OVER HILL WIND FARM

Further Environmental Information

Energiekontor UK Ltd

August 2018

Figure A PHASE 1 PEAT SAMPLE LOCATIONS / DEPTHS

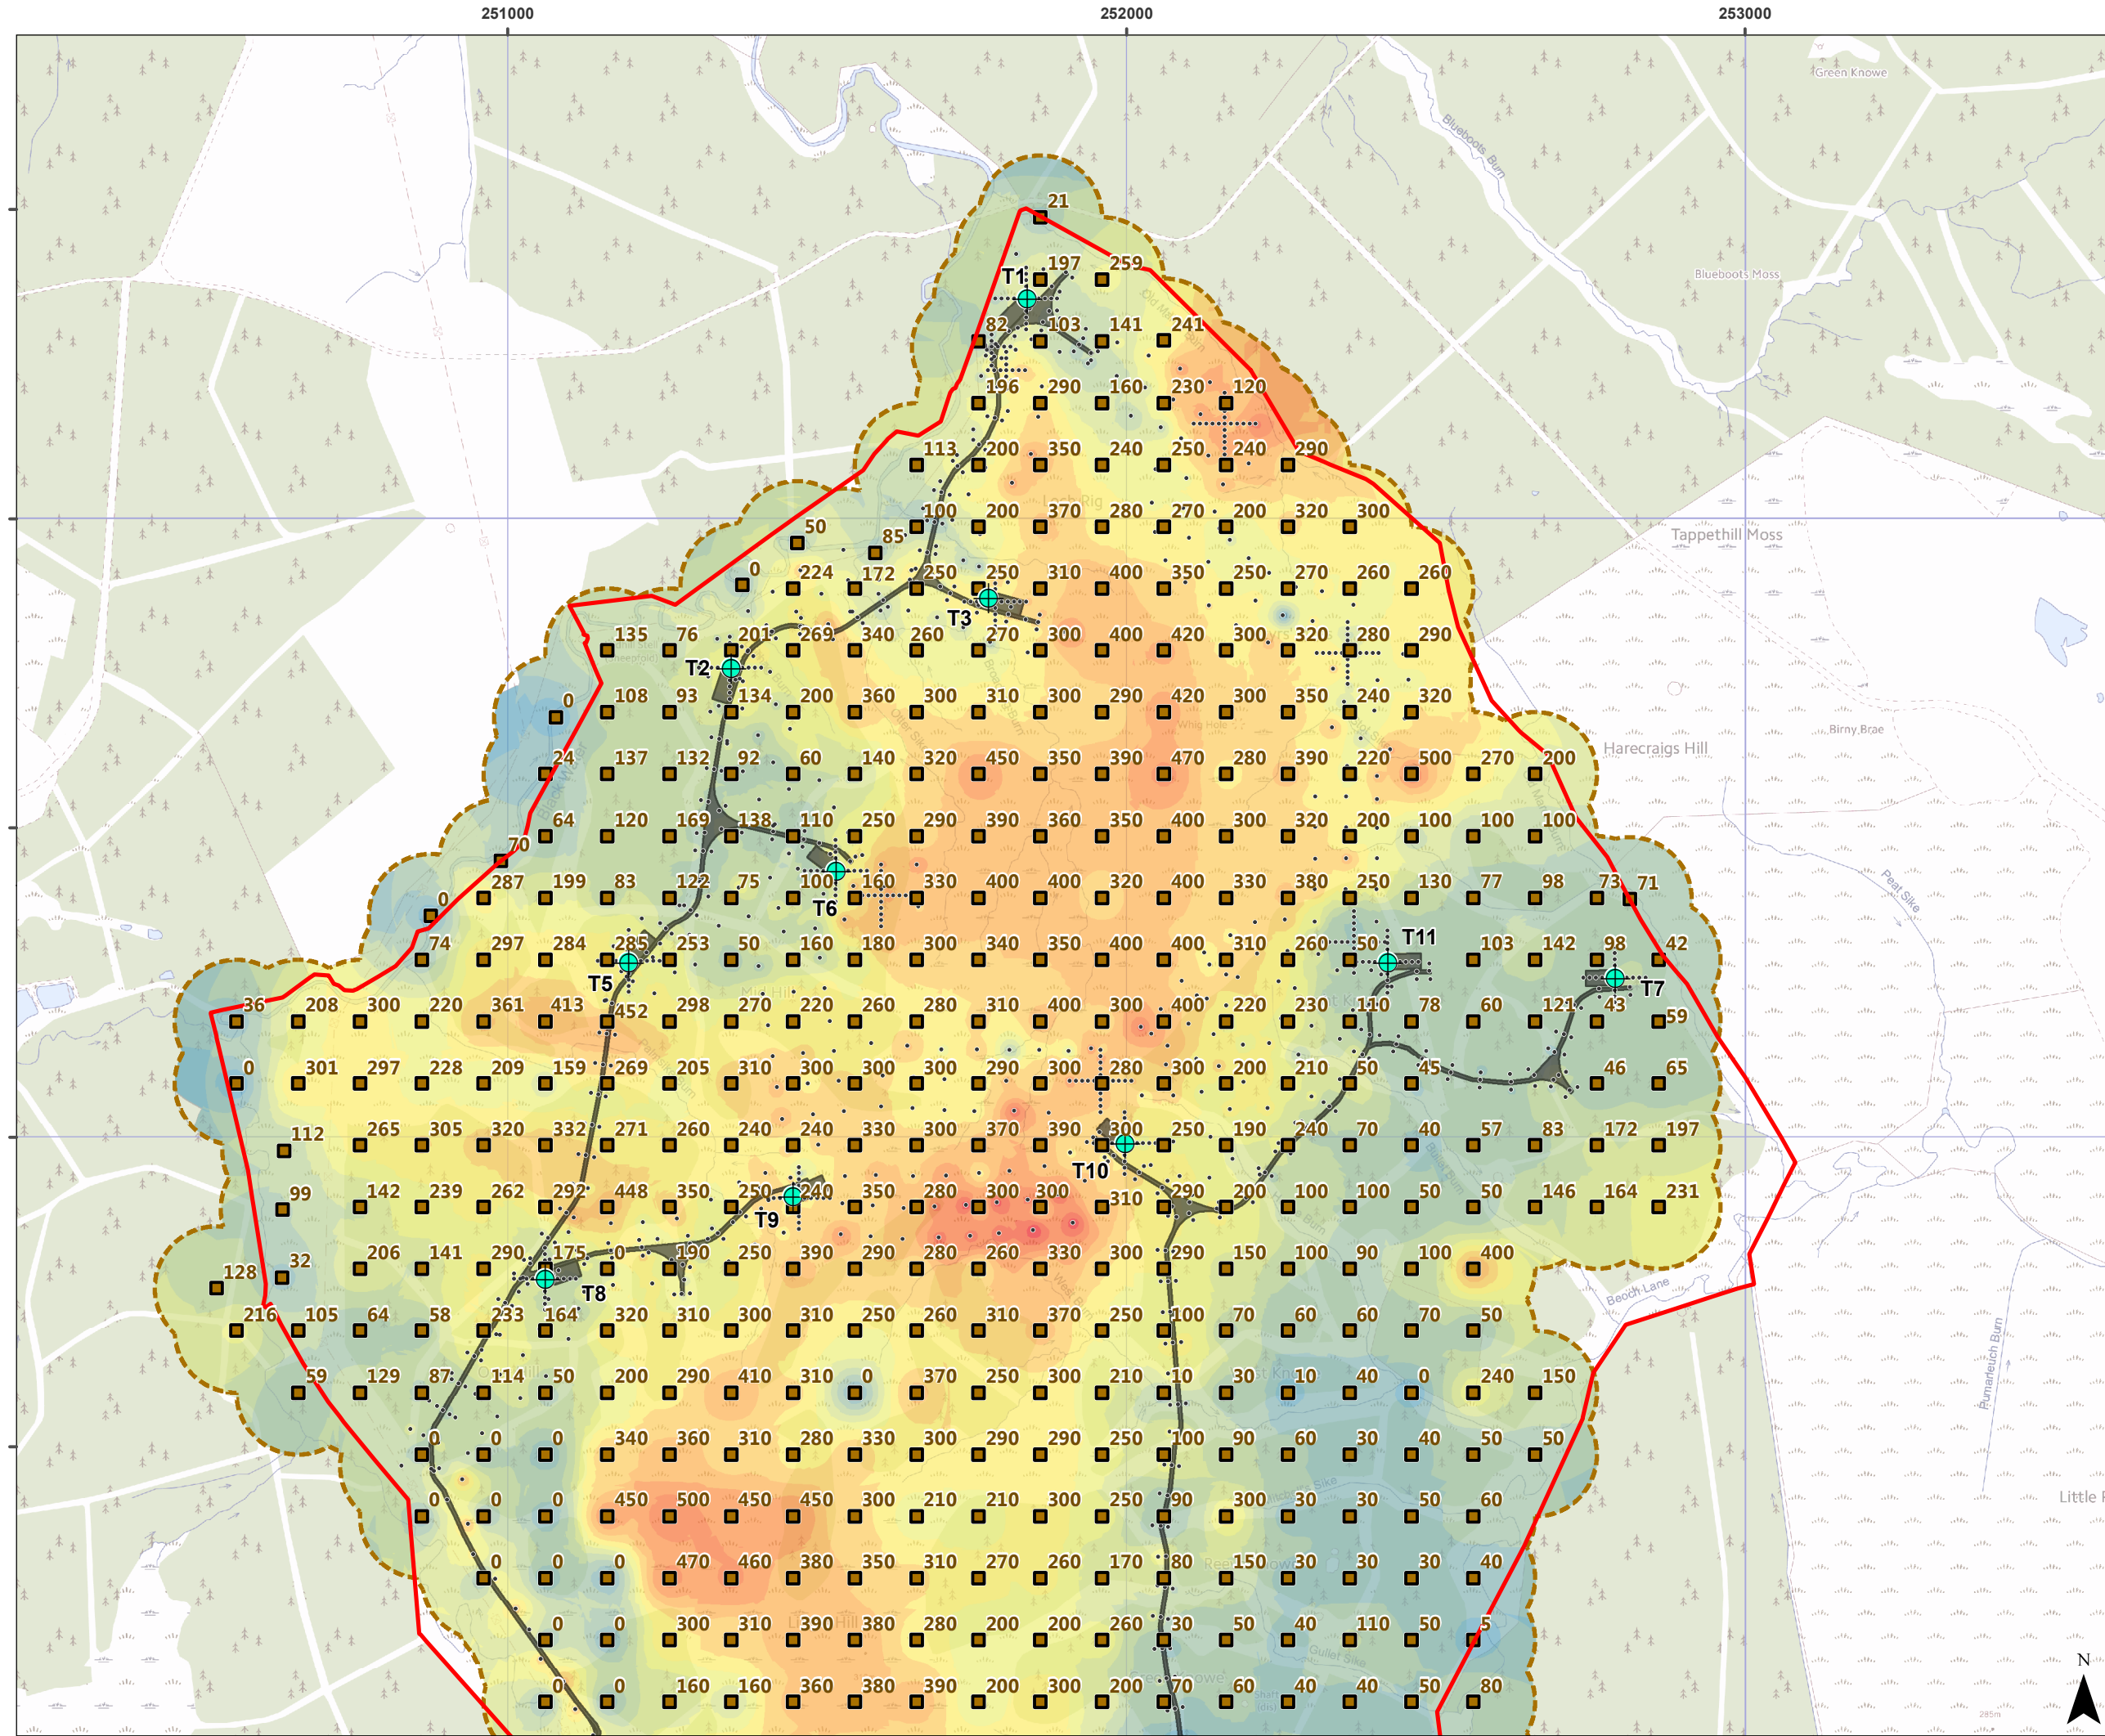
SNH Comment	Update Made for FEI August 2018 / Comment	Page number / section/paragraph
N/A	Figure A and B to DPMP – updated title.	
	Introduction to DPMP updated.	P1, Section 1, Paragraph 1
	Table 1, 2 updated. Changes comprise:	P3, Section 4.2, Table 1
